SPECIALIST STUDY: NOISE IMPACT ASSESSMENT: PROPOSED AMENDMENT – ALBANY WIND ENERGY FACILITY: CHANGE OF WIND TURBINE LAYOUT AND SPECIFICATIONS

The above-mentioned issue as well as report CES-IAWEF/ENIA/201904-Rev 0 is of relevance.

Figure 1: Layout previously evaluated as well as the proposed WTG locations

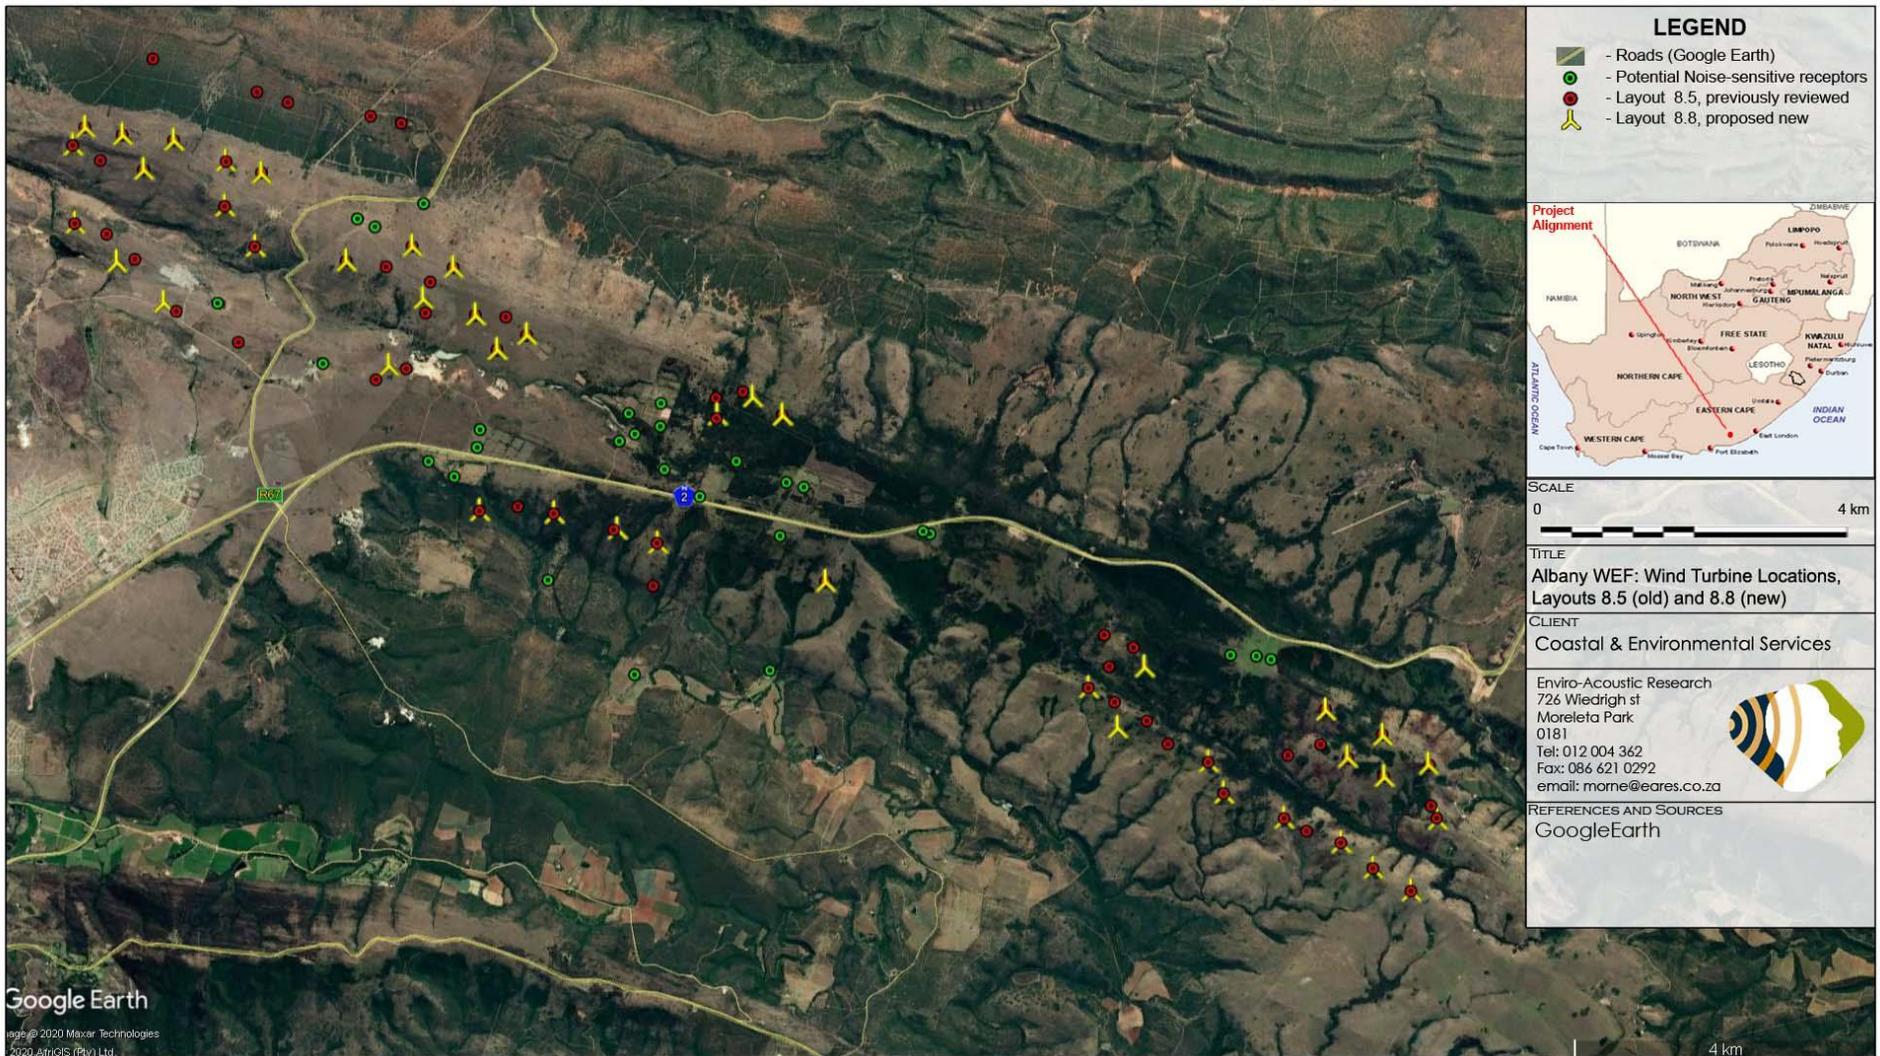
The developer of the Albany WEF has since optimized the layout (proposed new layout superimposed on the previous layout illustrated on **Figure 1**) of the facility, locating the wind turbines at optimal locations and changing the Wind Turbine Generators (WTGs) specifications as defined below:

- locates the WTGs on average further from the identified NSD;
- no WTG is moved closer than 1,000m from any NSD;
- the total number of WTG within 1,000 m from NSD 17 are reduced from three (3) to two (2). This reduction will result in a slight reduction in noise levels due to the reduction in cumulative noises (from three to two WTGs) and likely reduce the significance of the operational noise impact from **Medium** to **Low**. WTGs further than 1,000m from any identified NSD, with the closest WTG approximately 1,580 m from NSD10.

- the change will not increase the significance of the noise impact (the noise level will likely reduce at NSD 17 considering previous noise levels modelled);
- a full noise impact assessment with new modeling will not be required and the recommendations as contained in the previous document will still be valid;
- the cumulative noise impact will not change, as there are no new or proposed wind turbines (from a different WEF), located within 2,000m from identified NSDs that will cumulatively increase the noise levels;
- there are no new limitations or assumptions.

An updated noise impact assessment will not be required and the findings, mitigation measures and recommendations as contained in the previous document (report CES-IAWEF/ENIA/201904-Rev 0) will still be valid, subject that the developer use a wind turbine with a sound power emission level less than 105 dBA (re 10¹² watt). In terms of noise, this change will be acceptable.
